Technical *Info*

Changing the CT 909 K5 timing belt kit for VW/Audi/Skoda/Seat 1.8 T/2.0 to the CT 909 K10

(Change from hydraulic tensioning damper to mechanical tensioning pulley)

Fig. 1
Version to be replaced

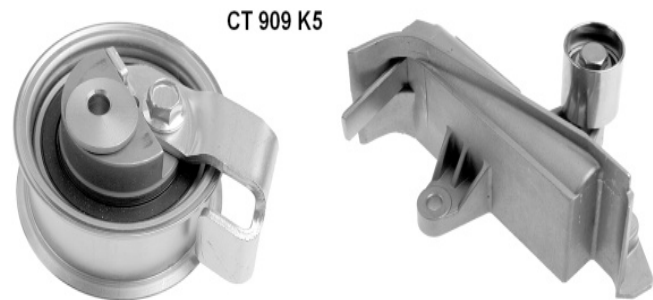
The components supplied in the timing belt kit do not match the components previously installed on the vehicle.

According to the OE manufacturer there is a new tensioning system with a mechanical tensioning pulley for the relevant vehicles specified in the catalogue. In this, the hydraulic tensioning damper with the small idler is replaced by a new version with just one bracket for the idler.

After fitting the timing belt and the bracket with the small idler, set the tensioning pulley to the mark by turning the eccentric clockwise. Check the setting after cranking the engine twice. Tighten the nut of the tensioning pulley to a torque of 23 +/- 3 Nm.
